CITY OF DALLAS  
CITY PLAN COMMISSION  
Thursday, April 9, 2020  
AGENDA

- (1) **S190-111**  
(CC District 7)
- An application to create three lots with area of 6,128 square feet each from a 0.422-acre (18,383 square feet) tract of land in City Block J/1486 on property located on Penelope Street, southwest of Gertrude Street.
- Applicant/Owner: Jamie Huerta  
Surveyor: Brian S. Rhodes  
Application Filed: March 12, 2020  
Zoning: PD 595 (R-5(A))  
Staff Recommendation: **Approval**, subject to compliance with the conditions listed in the docket.

**CITY PLAN COMMISSION****THURSDAY, APRIL 9, 2020****FILE NUMBER:** S190-111**SENIOR PLANNER:** Mohammad H. Bordbar**LOCATION:** Penelope Street, southwest of Gertrude Street**DATE FILED:** March 12, 2020**ZONING:** PD 595 (R-5(A))**PD LINK:** <http://dallascityattorney.com/51P/Supp%2058/ARTICLES/ARTICLE%20595.pdf>**CITY COUNCIL DISTRICT:** 7 **SIZE OF REQUEST:** 0.422-acre**MAPSCO:** 46R**APPLICANT/OWNER:** Jamie Huerta

Case no: S190-111

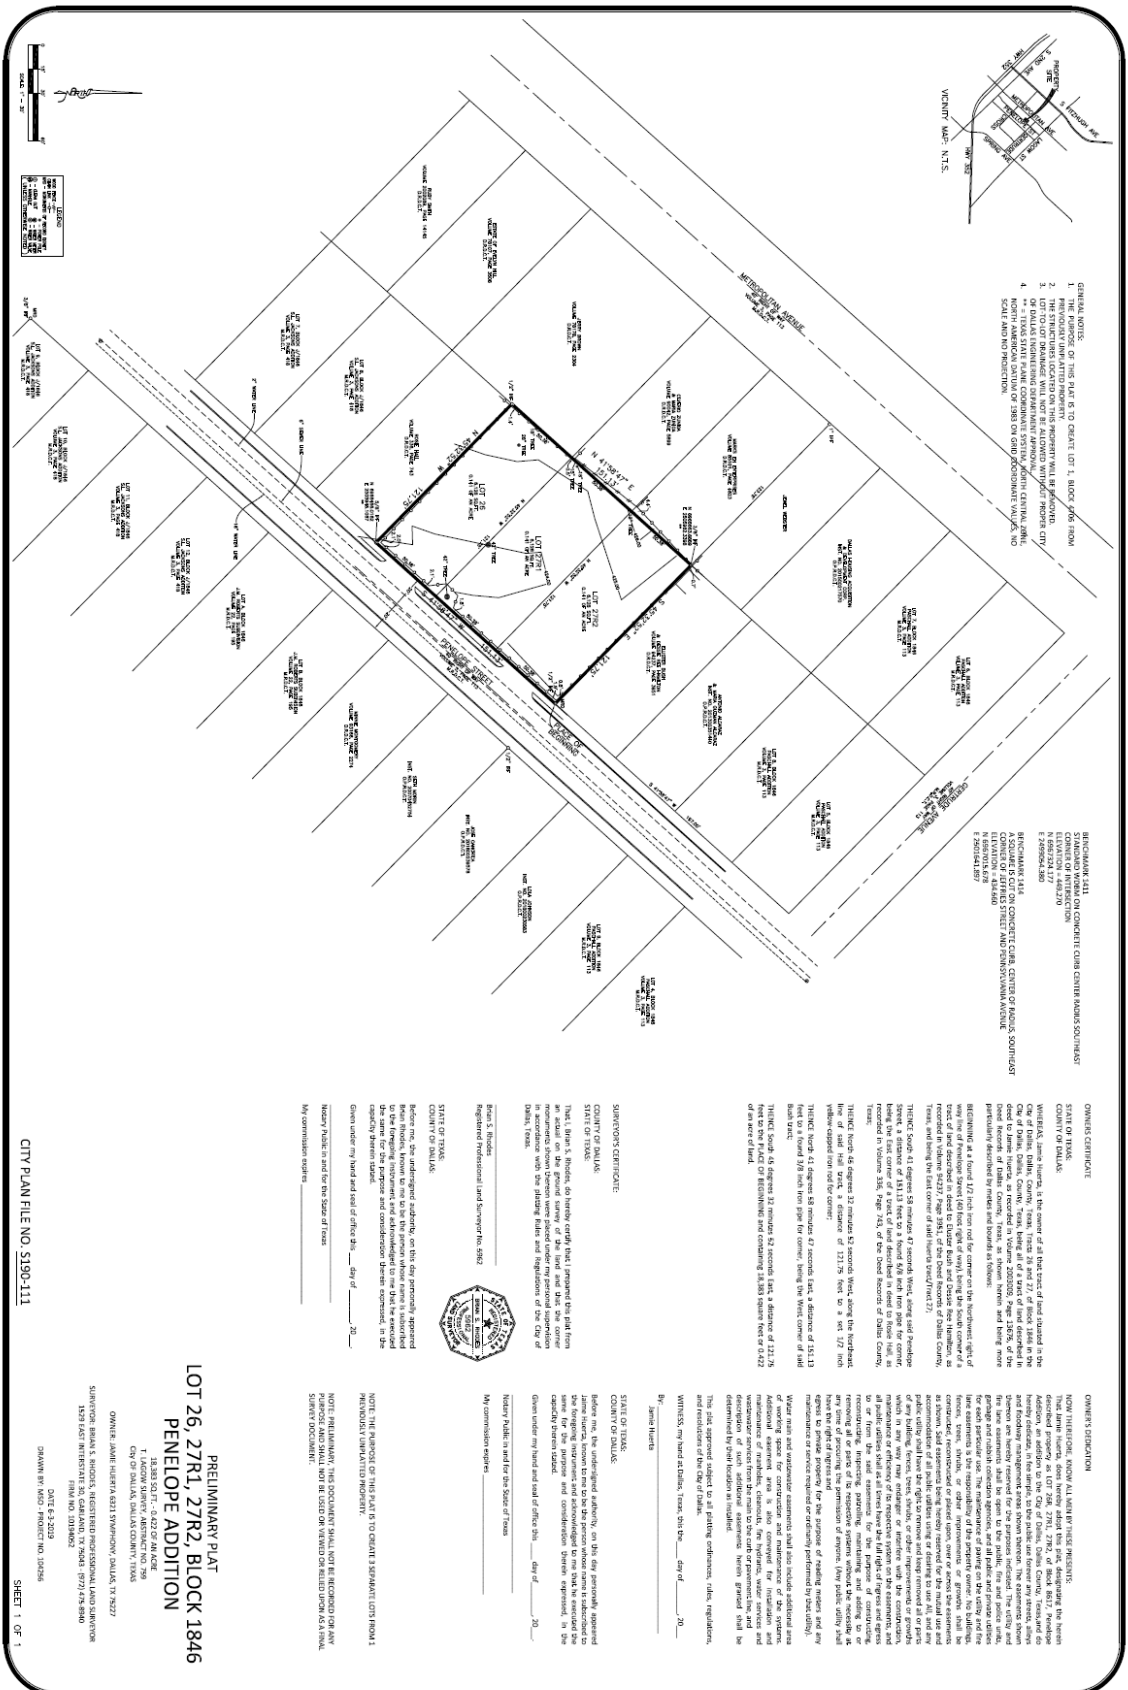
15. On the final plat, show the correct recording information for the subject property. Platting Guidelines.
16. On the final plat, show how all adjoining right-of-way was created. Section 51A-8.403(a)(1)(A)(xxii).

17. On the final plat, show distances/width across all adjoining right-of-way. Platting Guidelines.
18. On the final plat, show recording information on all existing easements within 150 feet of the property.

21. Wastewater main improvements are required by Private Development Contract. Submit water/wastewater engineering plans to 320 E. Jefferson Blvd., Room 200, Attention: Water and Wastewater Engineering.
22. On the final plat, identify the property as Lots 13 through 15 in City Block J/1846. Ordinance 1A, Page 131 pages 131-148, Section 2 (passed August 13, 1872).

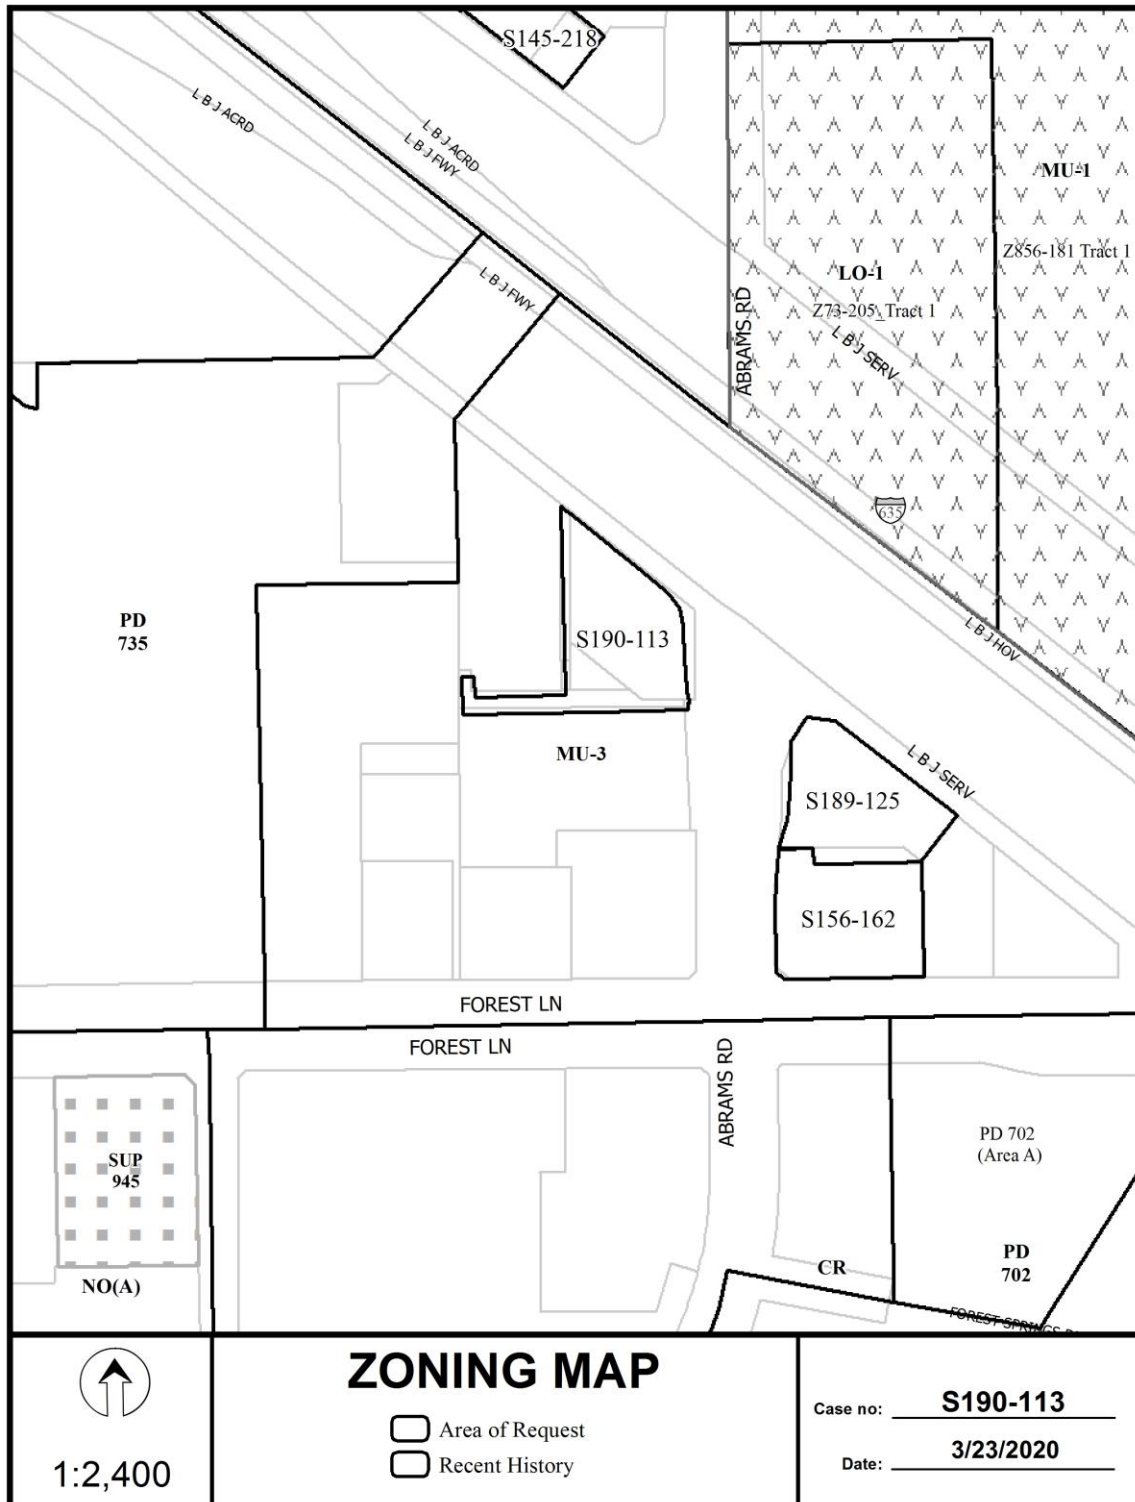
22. Prior to final plat, remove or relocate chain link fence encroaching from Abrams Road right-of-way and provide written conformation and /or pictures to Real Estate. Real Estate release is required prior to recordation of the plat.

23. On the final plat, change “LBJ Freeway (I-635)” to “Lyndon B. Johnson Freeway / Interstate Highway No. 635”. Section 51A-8.403(a)(1)(A)(xii)
24. On the final plat, change “Abrams Road (formerly known as Old Greenville Road” to “Abrams Road (F.K.A. Old Greenville Road) (F.K.A. County Road 236)”. Section 51A-8.403(a)(1)(A)(xii)

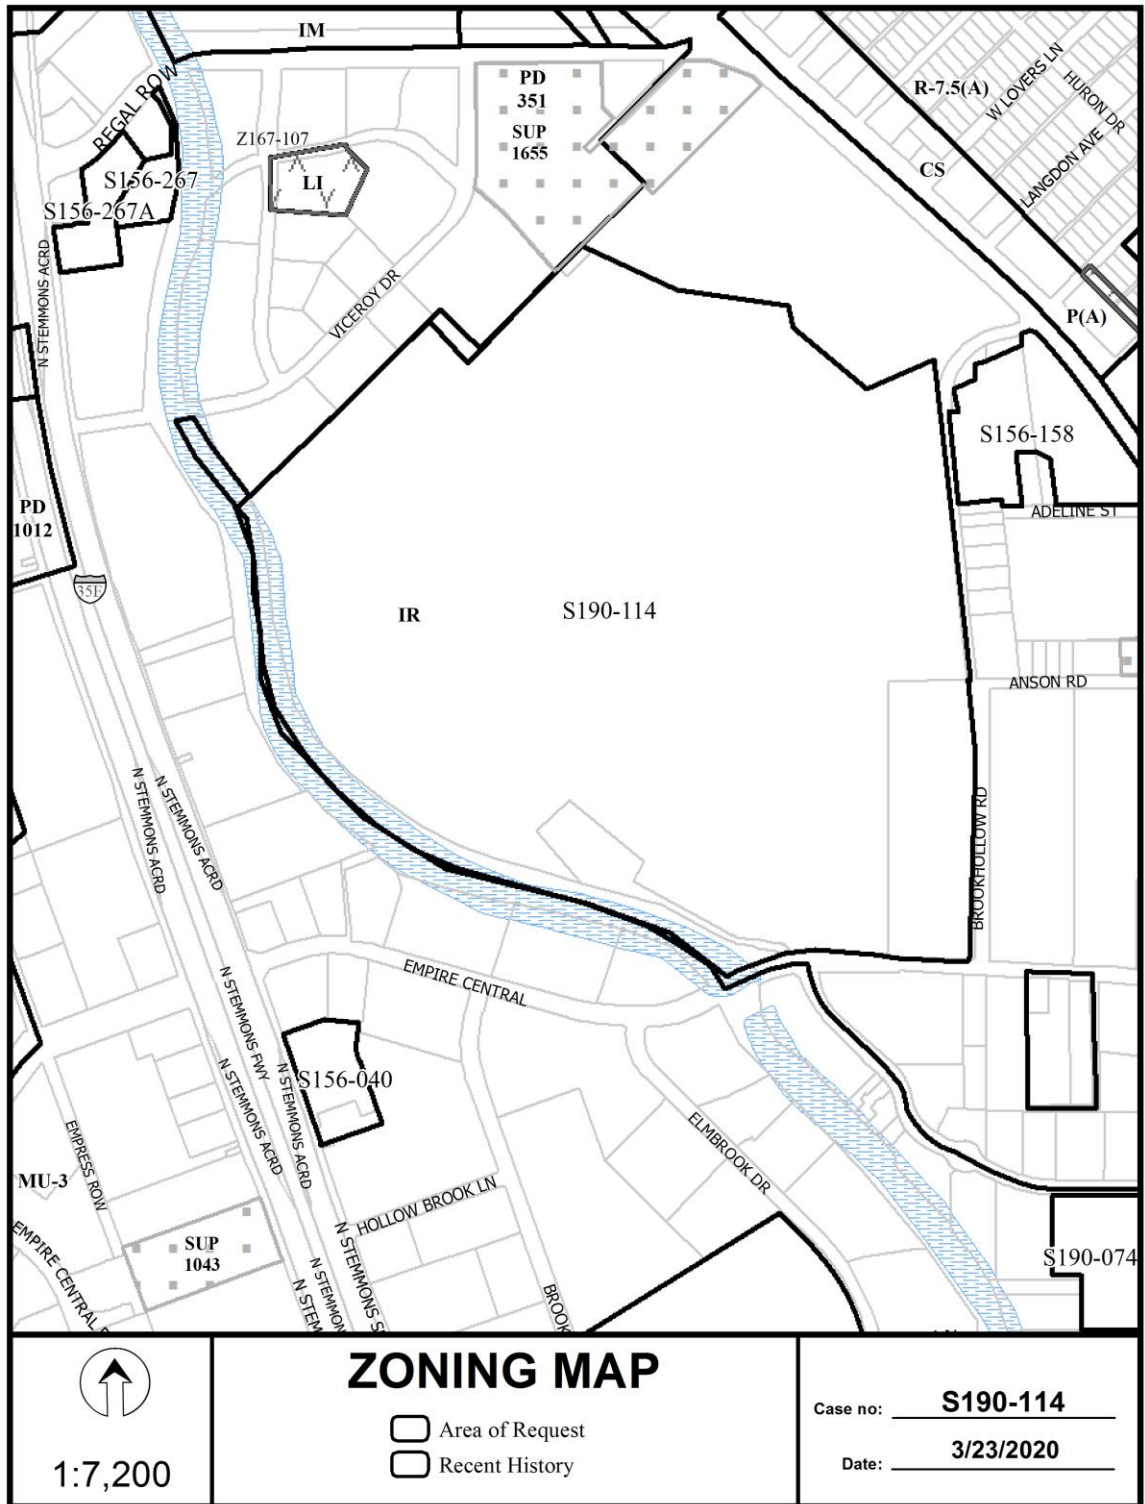
21. On the final plat, show the natural channel set back from the crest of the natural channel. Section 51A-8.611(d), Trinity Watershed Management.
22. Prior to submission of the final plat, set floodway monument markers and provide documentation that the monuments have been set. Section 51A-8.617(d)(1), (2), (3), and (4).

28. On the final plat, show all additions or tracts of land within 150 feet of the property with recording information. Platting Guidelines.
29. Prior to final plat, it is recommended to add another sheet showing the overall boundary with vicinity map and an index sheet location.

33. On the final plat, change all instances of “Empire Central Drive” to Empire Central (F.K.A. Proctor Street. Section 51A-8.403(a)(1)(A)(xii)
34. On the final plat, identify the property as Lot 1B in City Block A/7930. Ordinance 1A, Page 131 pages 131-148, Section 2 (passed August 13, 1872).

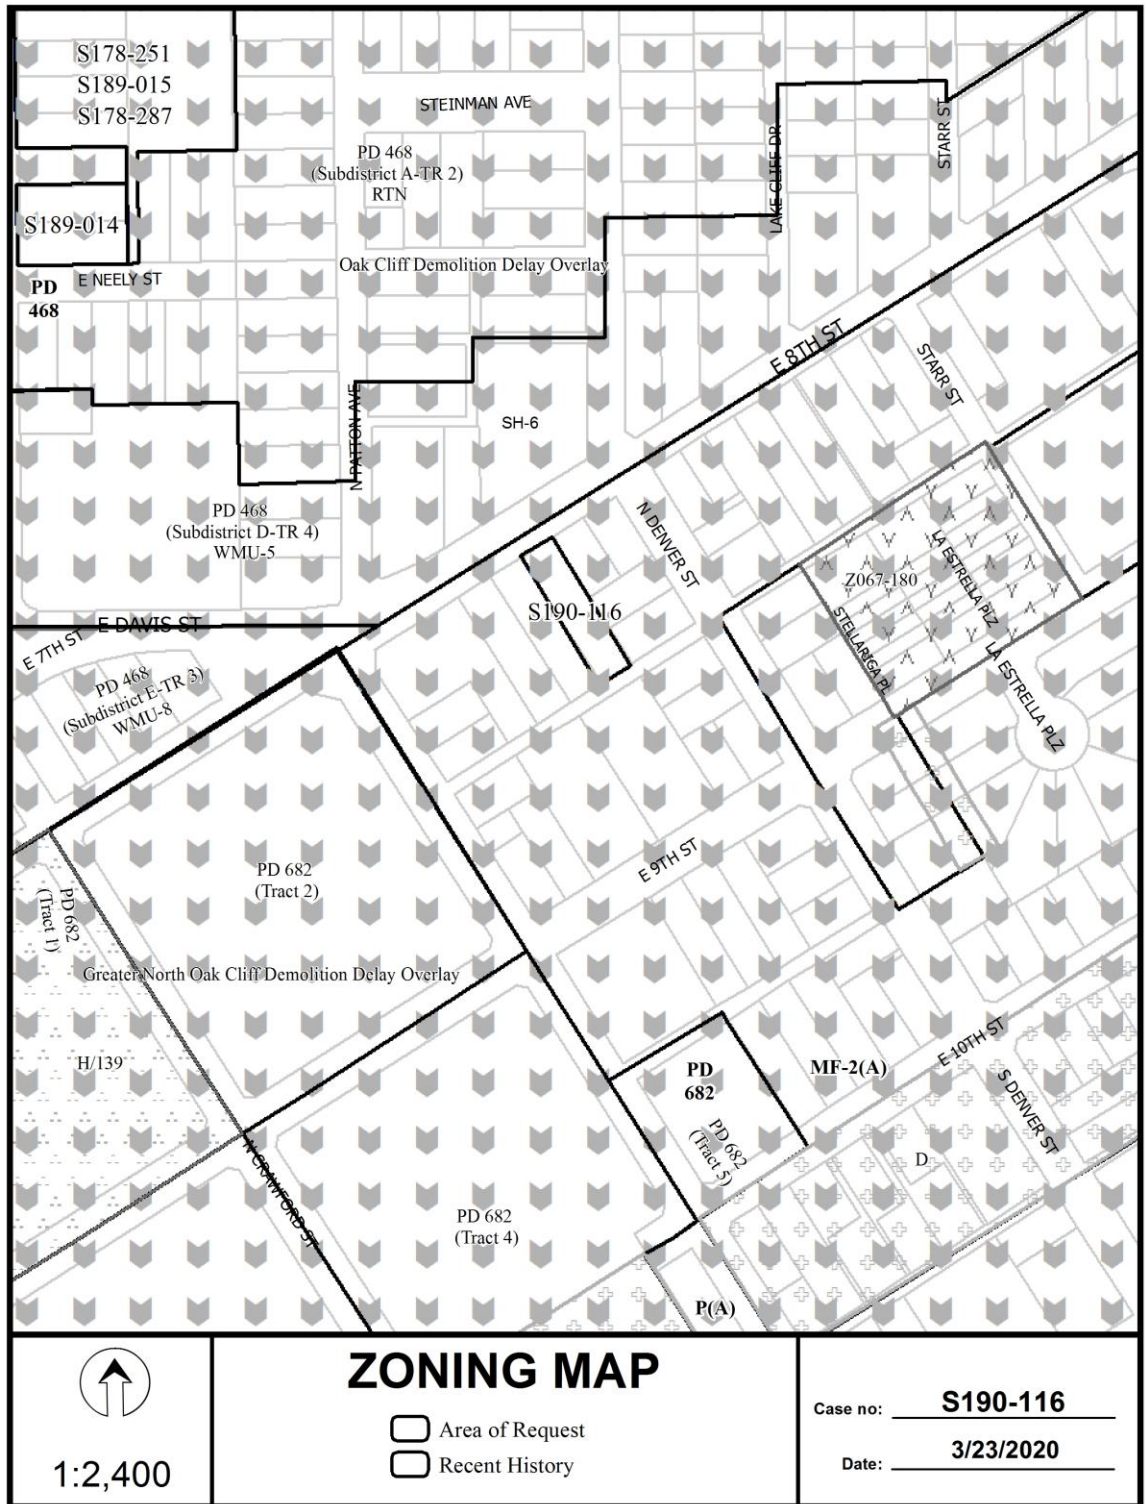
17. Prior to final plat, provide a 8.5" X 11" drawing showing distances between northeast property line and the existing structure that is depicted as 50.25' X 100',

21. On the final plat, change "Denver Street" to "Denver Street (F.K.A. Lake Street". Section 51A-8.403(a)(1)(A)(xii)
22. On the final plat, identify the property as Lot 3A in City Block 91/3074. Ordinance 1A, Page 131 pages 131-148, Section 2 (passed August 13, 1872).

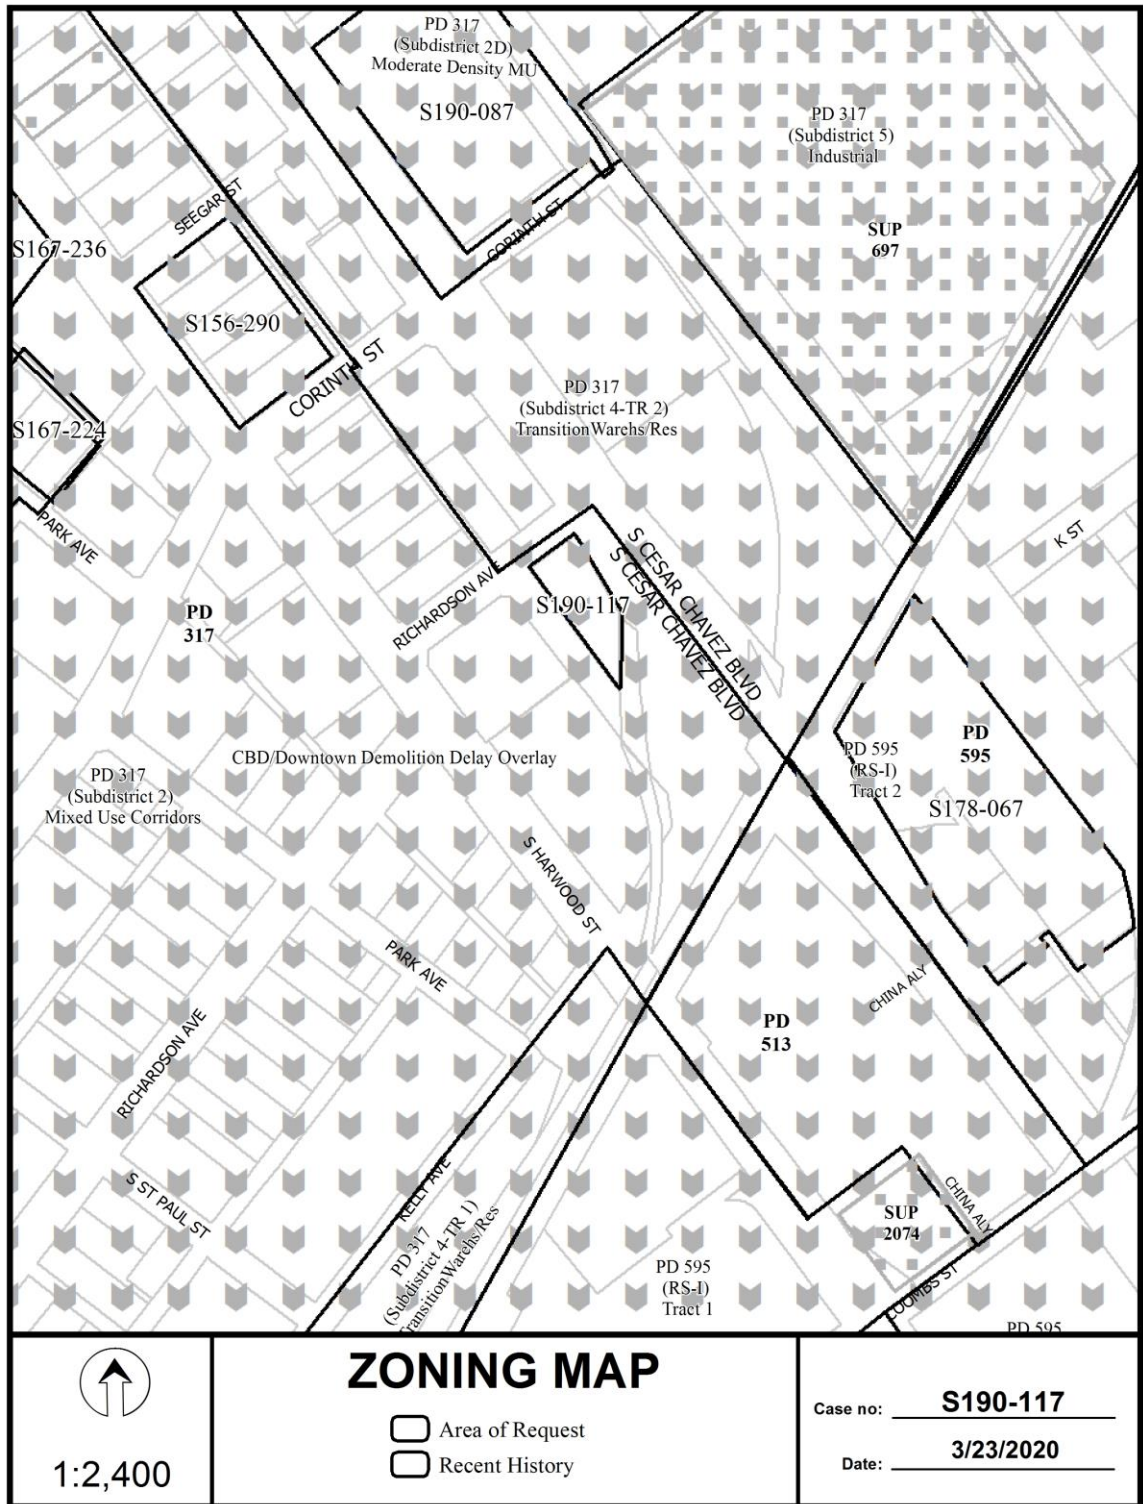
27. Capacity of existing wastewater system is questionable. Submit proposed wastewater discharge (gpm) of development for further assessment. Sections 49-60(b)(2)(d) and 49-60(d).

28. On the final plat, change “Richardson Street” to “Richardson Avenue”. Section 51A-8.403(a)(1)(A)(xii)

29. On the final plat, change “Cesar Chavez Boulevard” to “Cesar Chavez Boulevard (F.K.A. Central Expressway”. Section 51A-8.403(a)(1)(A)(xii)
30. On the final plat, identify the property as Lot 8A in City Block 6/926. Ordinance 1A, Page 131 pages 131-148, Section 2 (passed August 13, 1872).
